GEOCRES No. 30M13-67DIST. 6 REGION W.P. No. 150-87-01/02CONT. No. 89-62W. O. No. STR. SITE No. 37-1167 & 37-1168HWY. No. 427LOCATION Hwy 427 NBL over Hwy 407 &
Hwy 427 SBL over Hwy 407No of PAGES -

REPORT ON
FOUNDATION INVESTIGATION
FOR PROPOSED
HIGHWAY 407 AND HIGHWAY 427 INTERCHANGE

RE: General Arrangement Drawing Review
Hwy. 427 NB & SB O'passes at Hwy. 407
W.P. 150-87-01/02, Site 37-1167/8
District 6

The General Arrangement Drawing 37-1167/8-P1 has been reviewed by this office and the following foundation and geotechnical related comments are provided.

HWY. 427 N.B. & S.B.
0° PASSES AT HWY. 407
GENERAL ARRANGEMENT

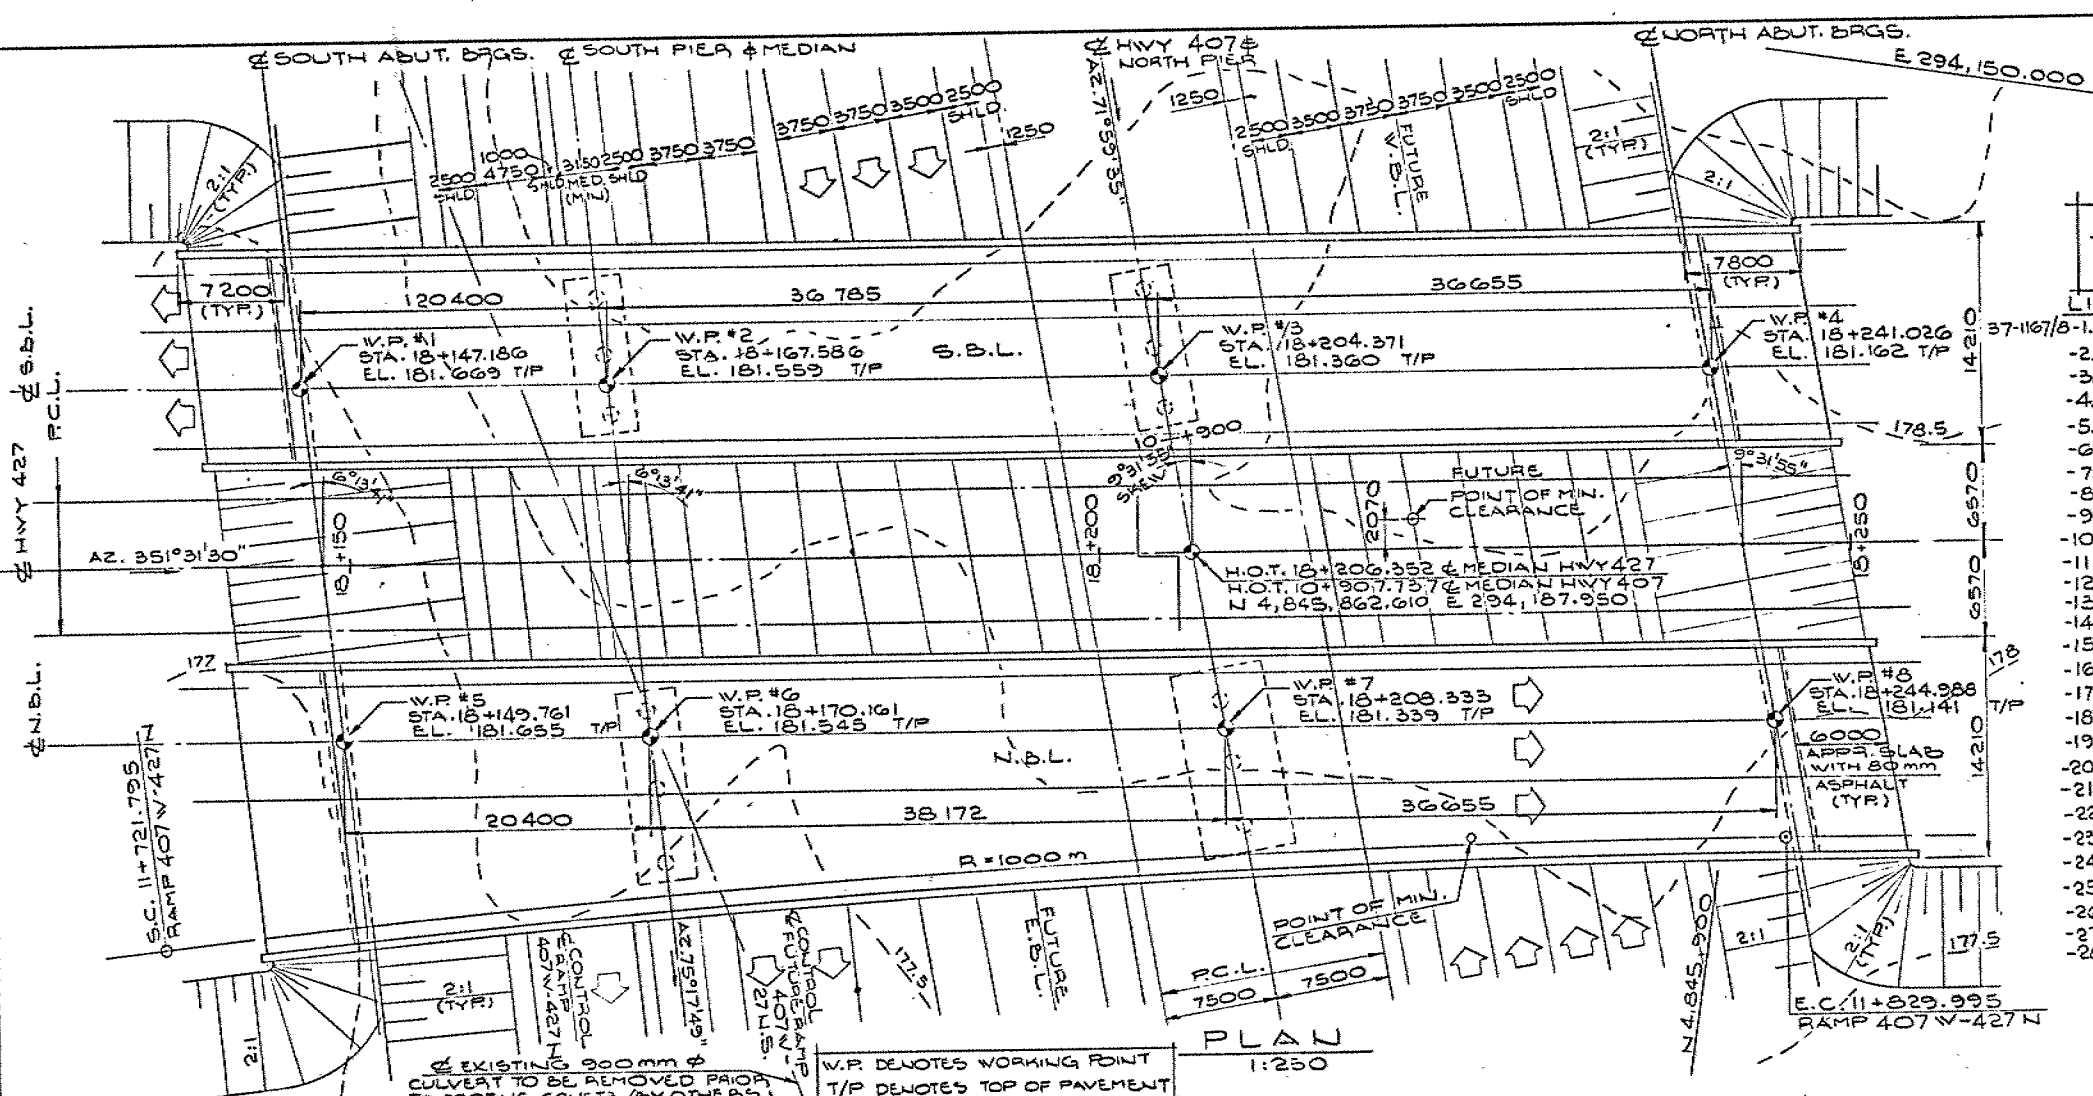
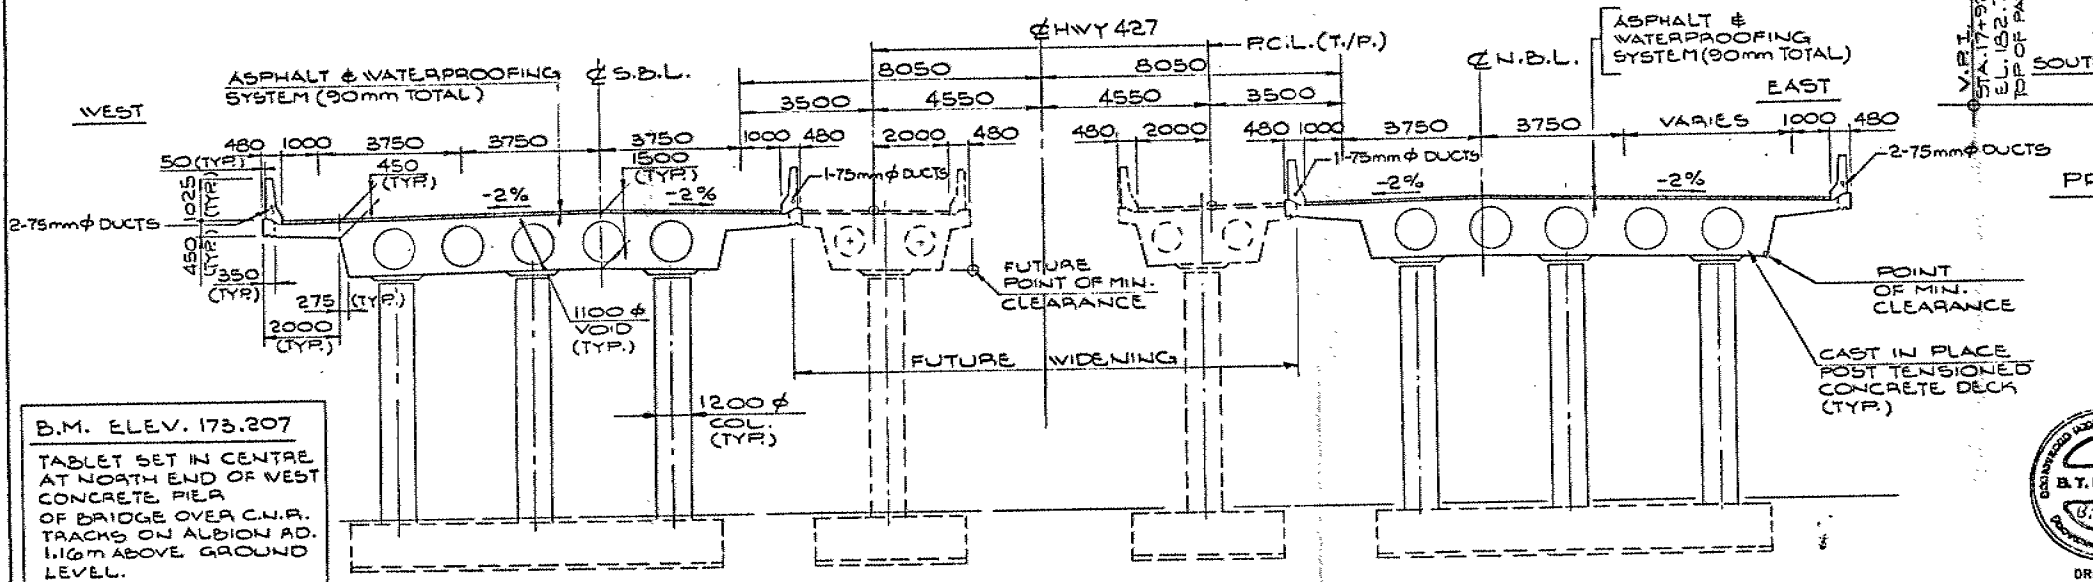
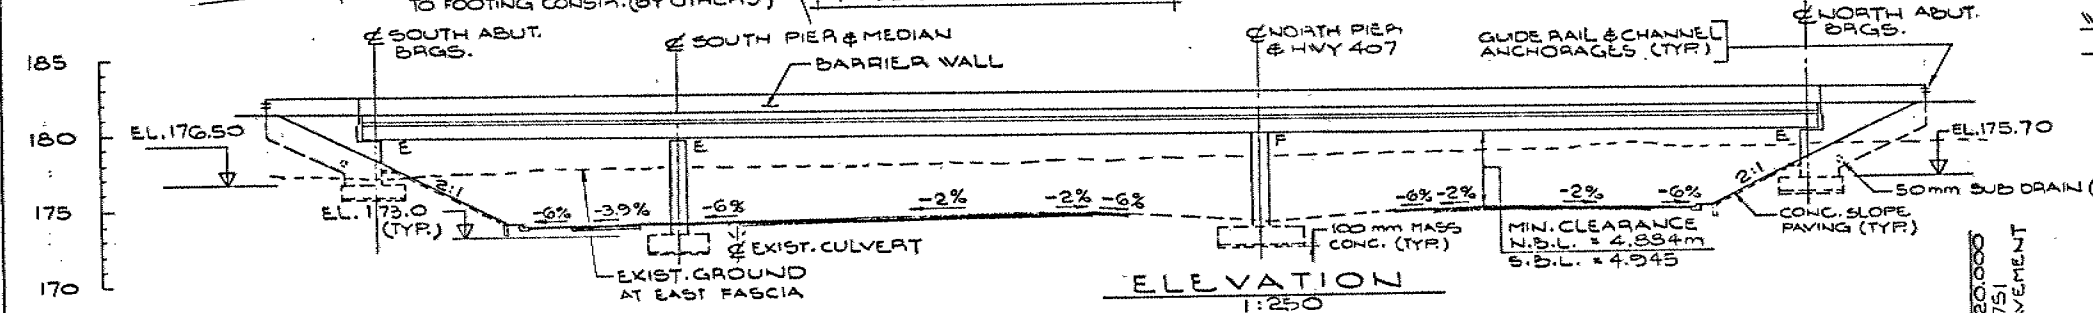
1. Excavations below the groundwater table will be required at the pier locations. A positive dewatering scheme will be required to prevent disturbance of the foundation soil. It has been suggested in the Foundation Report that oversize perimeter ditches and sump pumping may be sufficient. Alternatively, a well point system may be required. The high density of the soil may preclude the sheet pile option. In any case the contract should require that the prevailing groundwater elevation must be lowered a minimum of 0.5m below the base of the excavations and that the dewatering/excavation operations should not disturb the foundation soil.
